<h1 style="margin: 0;">INNER WEST COUNCIL</h1>	
<b>DEVELOPMENT ASSESSMENT REPORT</b>	
<b>Application No.</b>	10.2017.19.2
<b>Address</b>	33 Chandos Street, Ashfield
<b>Proposal</b>	Section 8.2 Review of refused modification of development consent for internal and external changes to approved boarding house
<b>Date of Lodgement</b>	20 September 2019
<b>Applicant</b>	Eugene Sarich
<b>Owner</b>	MicroNest No 1 Pty Ltd ATF MicroNest Ashfield Trust
<b>Number of Submissions</b>	8
<b>Value of works</b>	\$3,111,298
<b>Reason for determination at Planning Panel</b>	Recommended refusal of Section 8.2 Review
<b>Main Issues</b>	<ul style="list-style-type: none"> <li>Internal amenity and facilities</li> <li>Neighbouring amenity impacts</li> <li>Management of use</li> <li>External changes</li> <li>Accessibility</li> <li>Waste management</li> <li>Stormwater management</li> <li>Missing information</li> </ul>
<b>Recommendation</b>	Refusal

This report is an assessment of the application submitted to Council for Section 8.2 Review of refused modification of development consent for internal and external changes to approved boarding house at 33 Chandos Street, Ashfield. The application was notified and

**Figure 2:** Site plan showing approved building footprint (blue dotted line) and the proposed building footprint. The red dotted line indicates the footprint of the refused scheme.

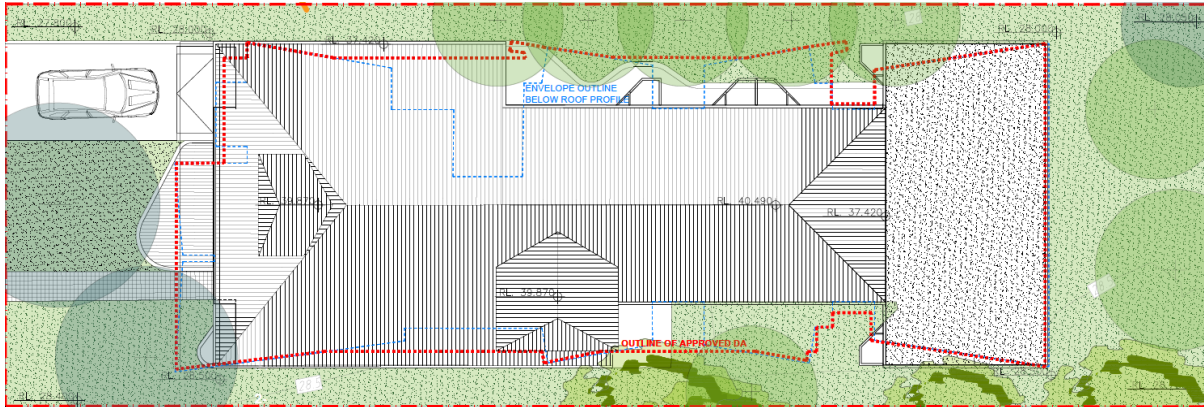
The revised proposal has a uniform 6.8m front setback which results in a less satisfactory relationship to No. 35 and the streetscape.

Generally the side setbacks are increased in the 'central' portion of the building but reduced in the front and rear portions of the building (see Figure 2 below). As discussed below, insufficient information has been provided regarding the proposal's impact on neighbouring amenity thus the appropriateness of the setbacks cannot be determined.

Given the lack of information, it has not been demonstrated that the development represents good design.

**33 Chandos Street**  
**Ashfield**  
**LEVEL ROOF PLAN**

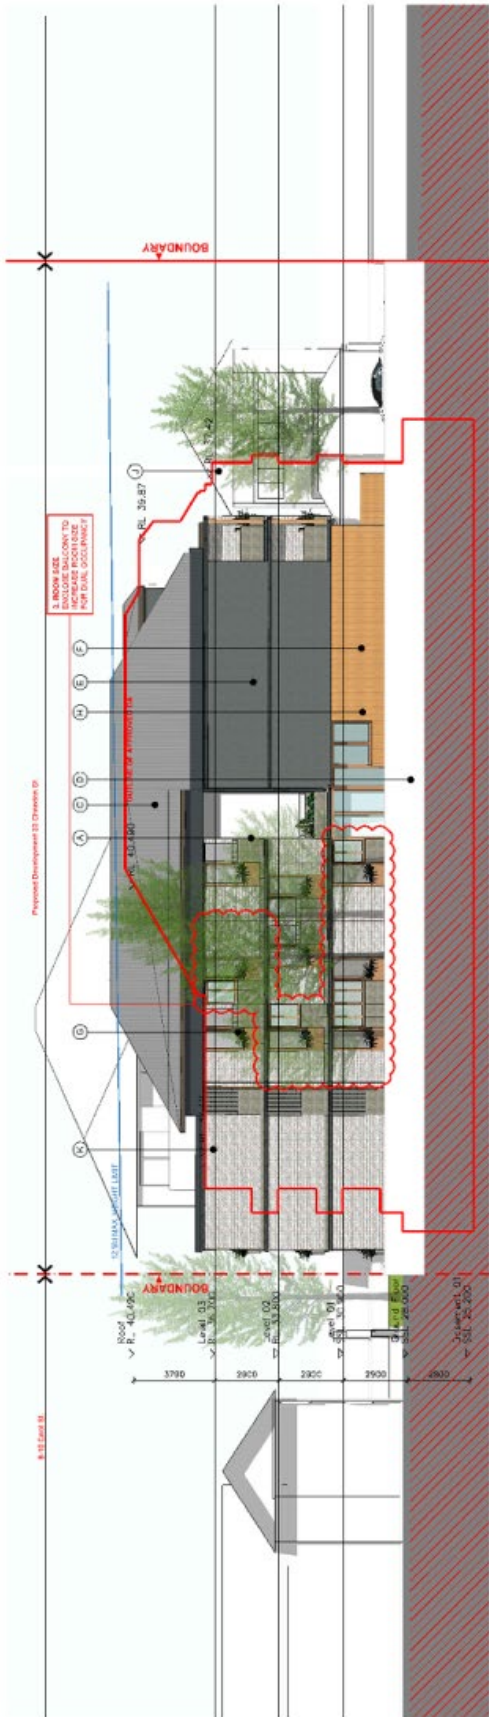
The proposal includes significant changes to the roof form and a substantial attic level which includes two dormer windows. The proposed attic level is entirely occupied by a space labelled 'plant/storage'. Access to the attic level is via the communal stairwell.

The proposed dormer windows are not supported as they relate to a designated non-habitable space and thus add unnecessary bulk to the building. Insufficient information has been provided as to why dormer windows are required, who will have access to the attic level storage area, what 'plant' equipment will be placed here, or why mechanical plant and equipment cannot be located elsewhere in the building without adding unnecessary bulk.

**33 Chandos Street  
Ashfield  
Side Elevations**

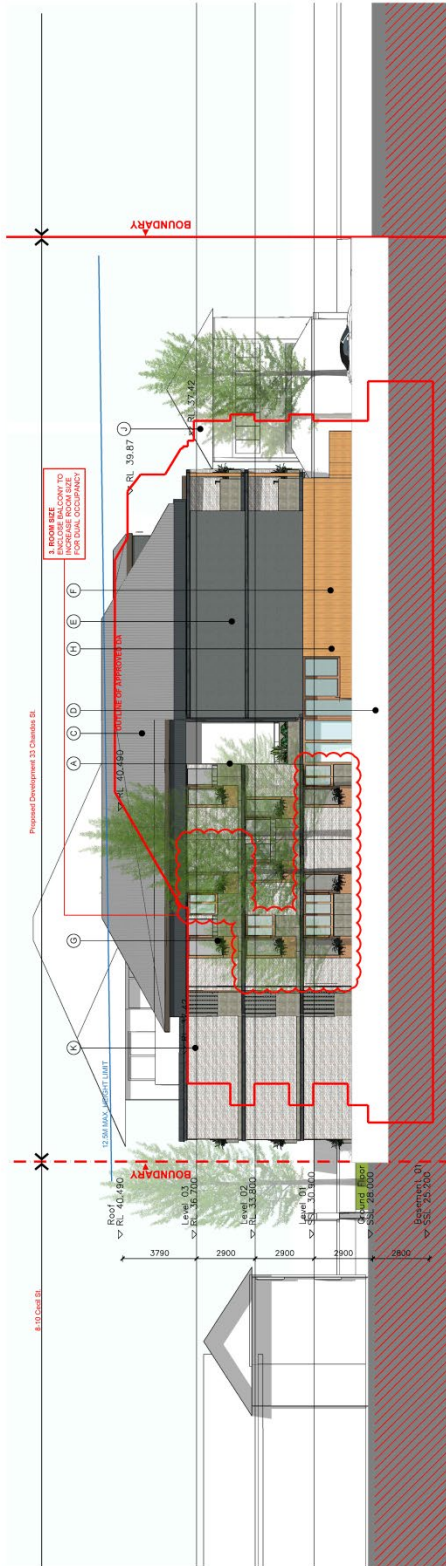
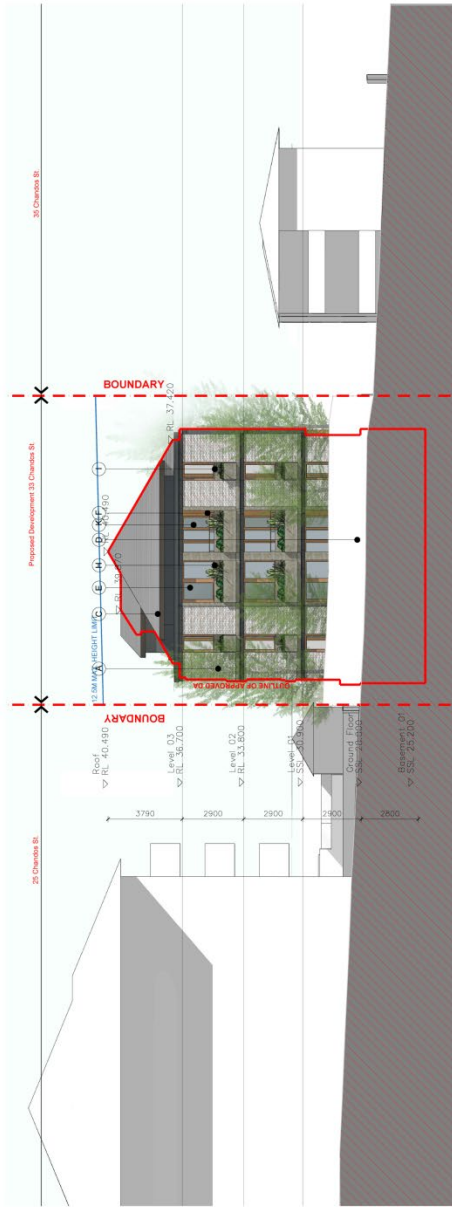
Insufficient detail has been provided regarding the 'glass block' on the eastern (side) boundary associated with the first and second floor common corridors. The side elevation annotates this as 'aluminium frame sliding doors and sliding windows'.
